SERVICE *No. 926A* BULLETIN

SUBJECT:

Hartzell Service Bulletin No. 165 E,
Inspection for Cracks in Certain
Three Blade "Y" Shank Aluminum
Propeller Hubs

SERVICE BULLETIN 165E

Figure 1. Hub Grease Fittings

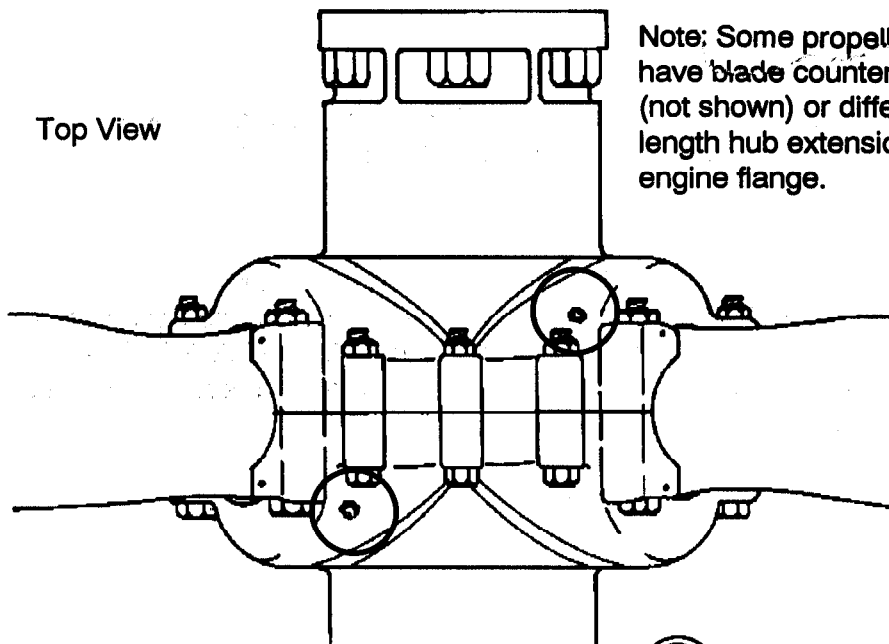
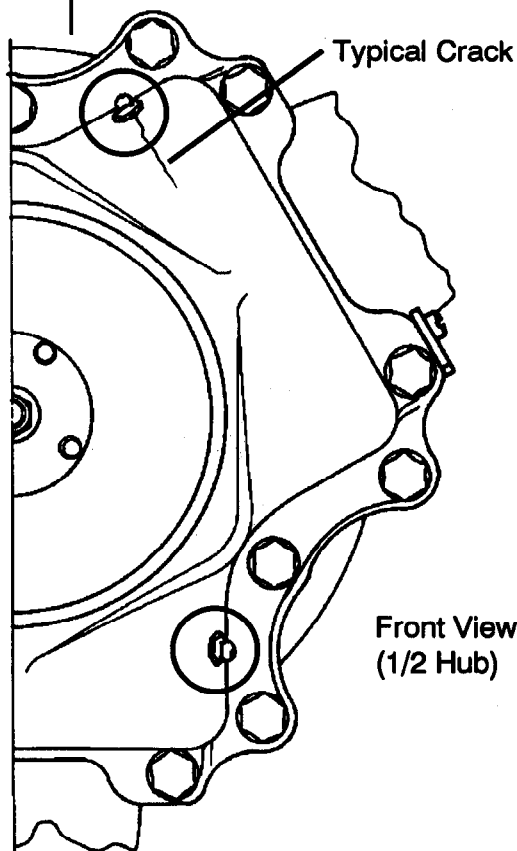
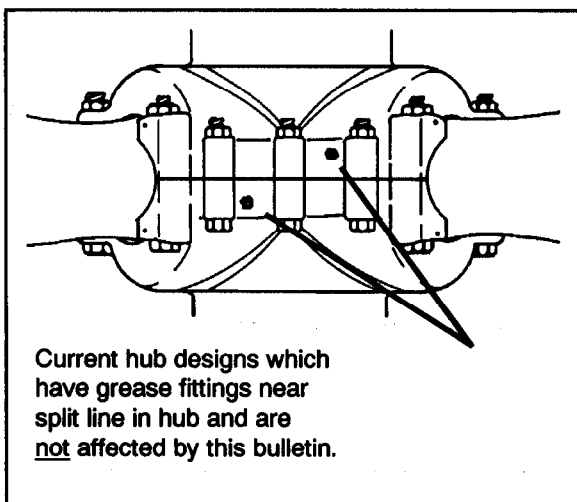
NOTE: During 1983, a hub design change relocated the grease fitting holes near the hub parting line (see Figure 1). The earlier-design hubs are listed as affected serial numbers, however, there may be a few hubs listed that are of the later type. Any hub found to be of the current configuration does not require compliance with this Bulletin. Any hub with the old configuration requires compliance.

3. Use 10X magnifying glass and light source to perform careful visual inspection of the hub for hairline cracks in the general vicinity of blade retention bearings, but primarily inspect the grease fitting areas as shown in Figure 1. Perform inspections with grease fittings installed.

- 2) Scan probe gradually around each of the six grease fittings on the propeller hub. See Figure 1, scan probe in a manner to cross typical crack indications (rather than scanning in strokes that may be parallel to typical crack indications). The center of the probe tip must pass within 1/4 inch of the grease fittings and outward from the fitting as far as practical (up to 2 inches). The initial scanning around the grease fitting should consist of a circle with the probe as close to the grease fitting hole as possible. Perform subsequent scans of concentric circles around the grease fitting with no more than 1/10 inch spacing between circles.

Circled areas encompass grease fittings to be inspected at two points on each blade socket

Current hub designs which have grease fittings near split line in hub and are not affected by this bulletin.

Figure 2. Hub Rework

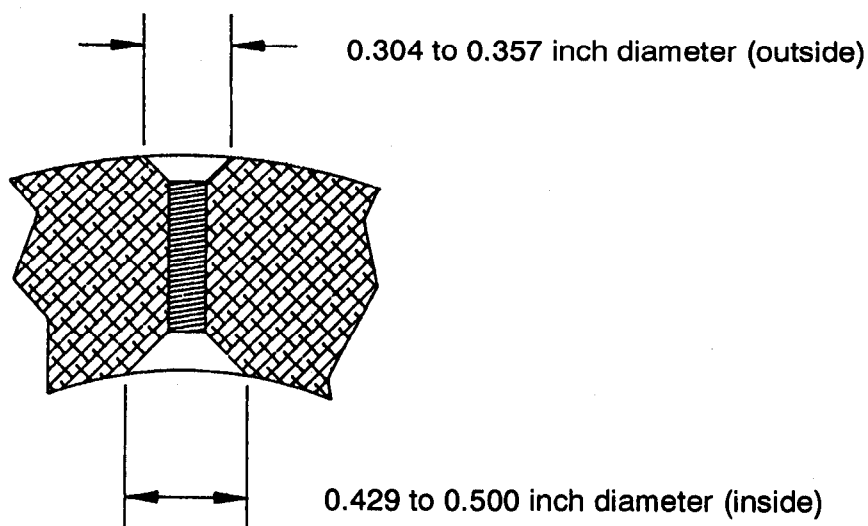
3. Using a 6 fluted, 45° chamfering tool (Hartzell part number 57BST5845), cut a chamfer to 0.429 to 0.500 inch diameter on the inside of the hub at each grease fitting location. Using the same tool, also cut a chamfer 0.304 to 0.357 inch diameter on the external side of each grease fitting hole. See Figure 2.

- a. Chamfering may be performed with a hand-held variable speed drill. Vary the RPM and force on the drill to minimize tool chatter. Testing on a scrap hub is recommended prior to performing this operation.

- b. Check diameter of chamfer using a dial caliper. Hub retirement is required if chamfer exceeds maximum diameter.
4. Polish any sharp edges created by the chamfering tool with 320 grit (or finer) emery cloth or sandpaper.
